Lemon Creek Ranch Lift Station RFCSP
Solicitation Number: CO-00490
Job No.: 21-3000

ADDENDUM 3
December 15, 2021

**SAN ANTONIO WATER SYSTEM
LEMON CREEK RANCH – UPSTREAM SANITARY SEWER PHASE 1B –
REGIONAL LIFT STATION**

LEMON CREEK RANCH – UPSTREAM SANITARY SEWER PHASE 1B
 SHEET
 ELECTRICAL BUILDING WALL PROFILES

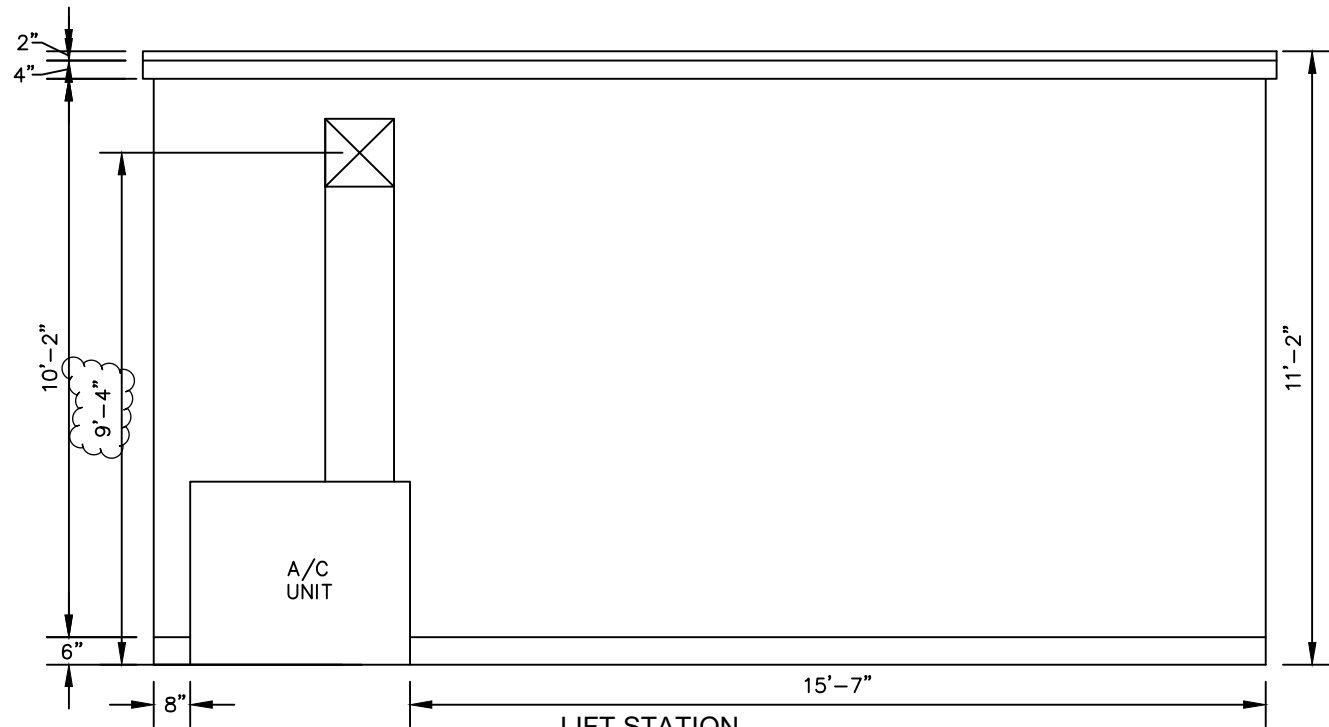
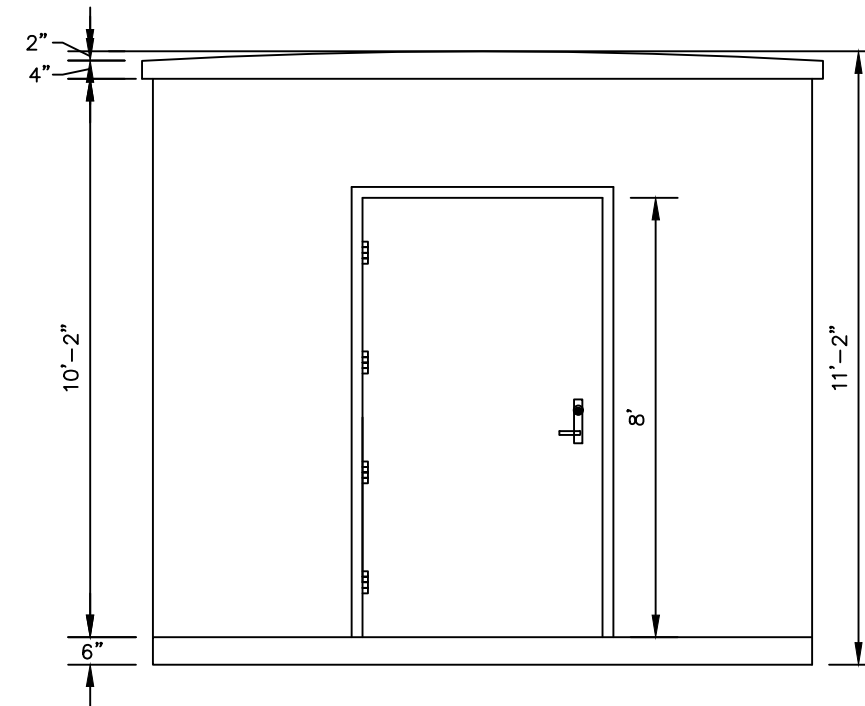
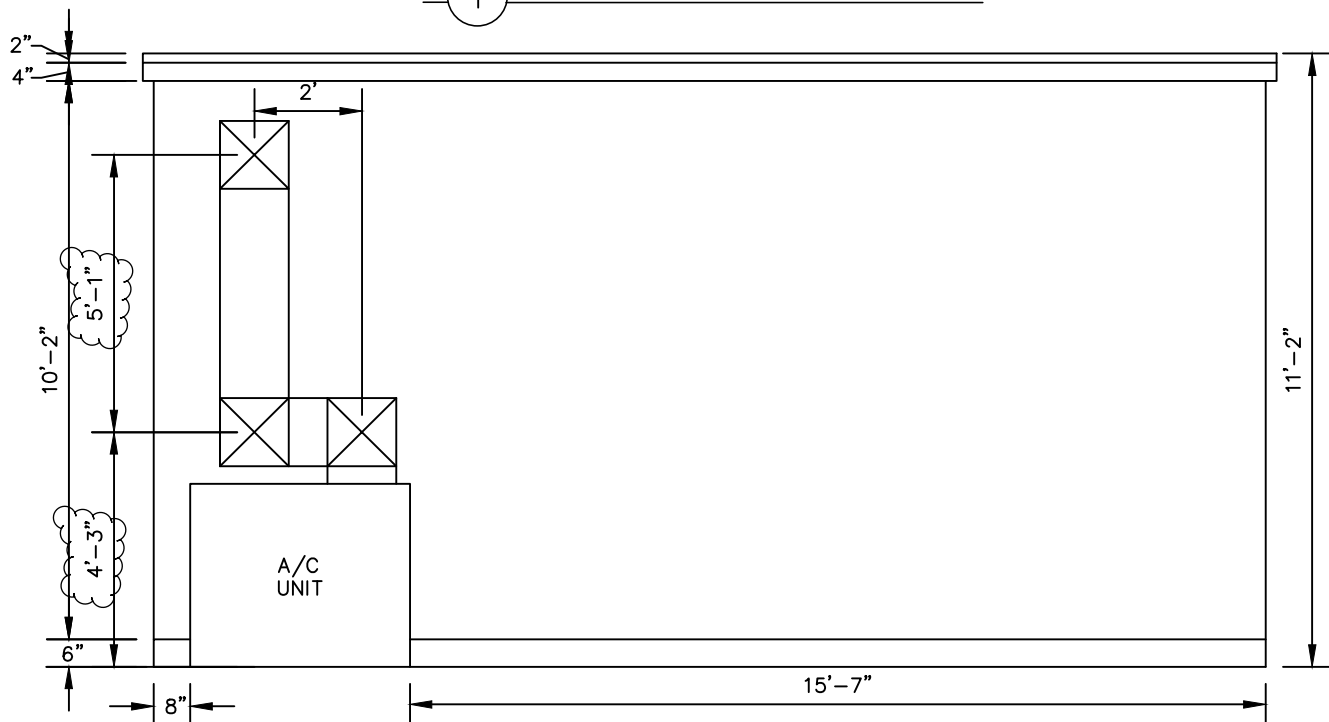
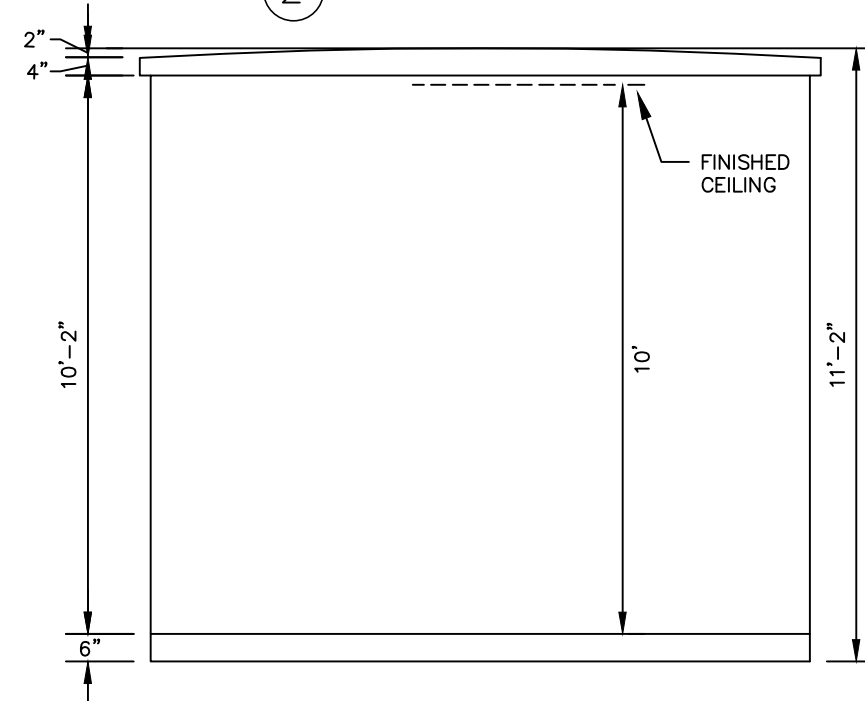
7. Question: Cannot find any details on the HVAC system requirements for this project. Referencing sheet LS16, E9 etc. and cannot find any Basis of Design for the HVAC equipment, duct sizes, grill selections etc. The only reference I see is Specs Section 13120 Precast building para 2.06 which provides a small detail of the HVAC units. Want to ensure that there isn't any additional requirements that have not been released.

Response: Additional dimensions have been added to sheet LS17. There are no additional requirements for the HVAC system. The HVAC system specified in Specification Section 13120 Precast Electrical Building paragraph 2.06 has been designed per SAWS cooling/heating requirements and building insulation requirements which include the following:

- *Maintaining an internal temperature of 70 degrees while the external ambient temperature is 105 degrees.*
- *Maintaining an internal temperature of 45 degrees while the external ambient temperature is 25 degrees.*

LEMON CREEK RANCH – UPSTREAM SANITARY SEWER PHASE 1B
SHEET
ANTENNA MAST AND MISCELLANEOUS DETAILS

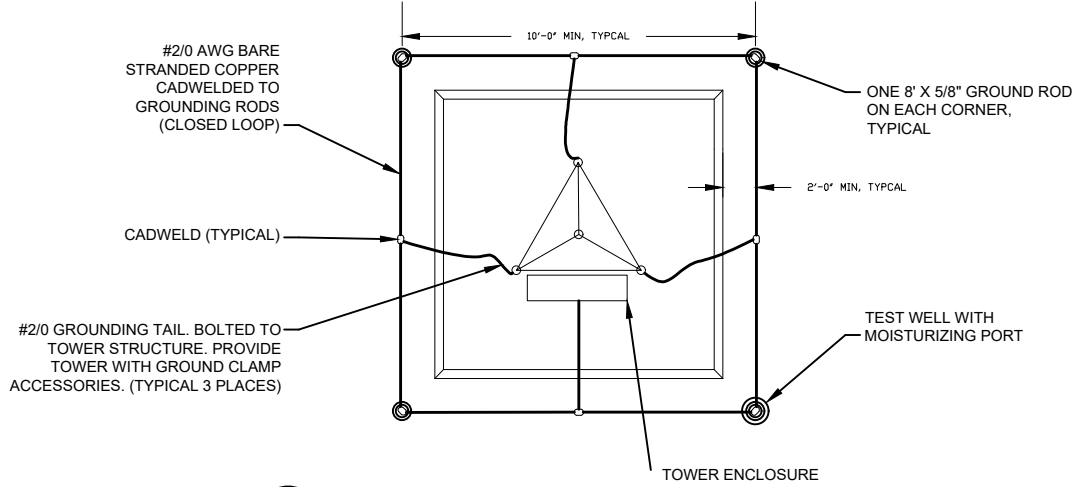
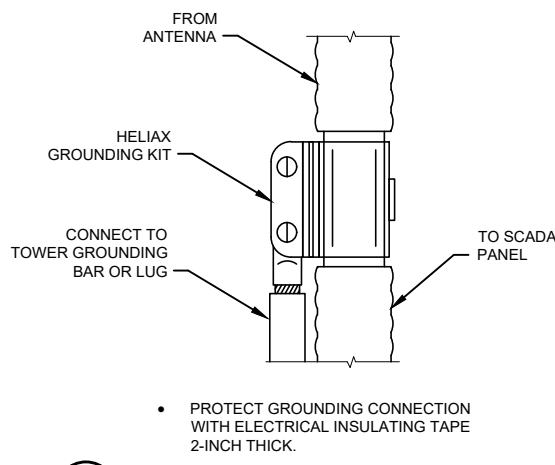
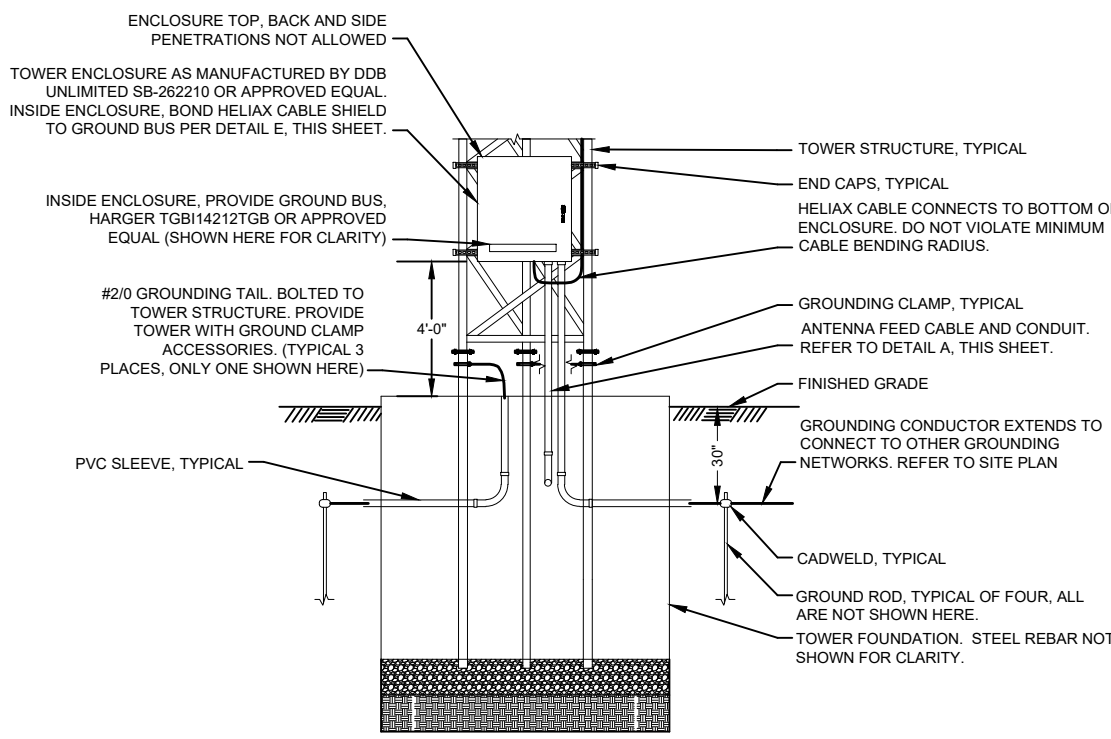
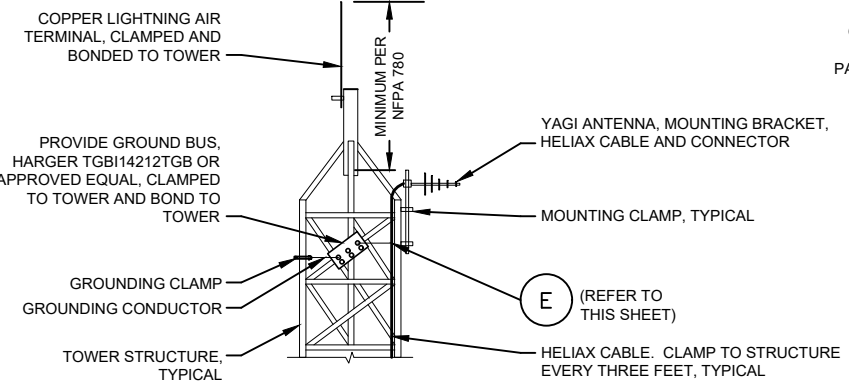
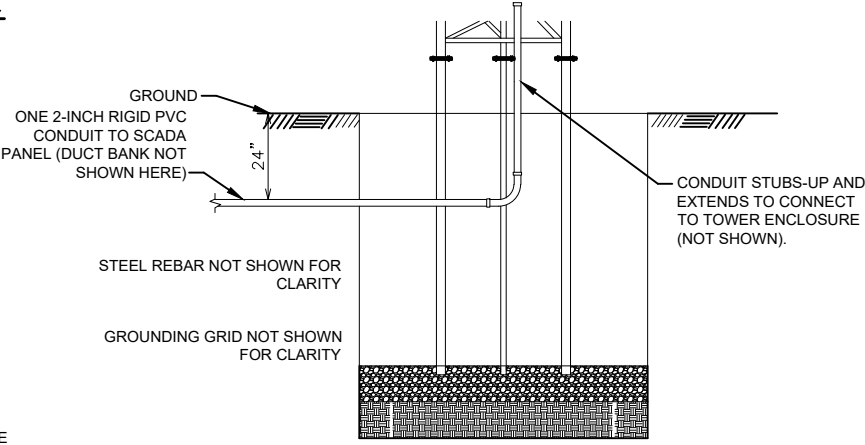
10. Question: On drawing E8 the Tower notes call out for a Rohn Self-Supported Tower. In the Tower specs #40 60 00 it calls out for a Saber Tower. Which one is recommended?

Response: A Saber tower is recommended. Sheet E8 has been revised to call out a Saber tower instead of a Rohn Self-Supported Tower.
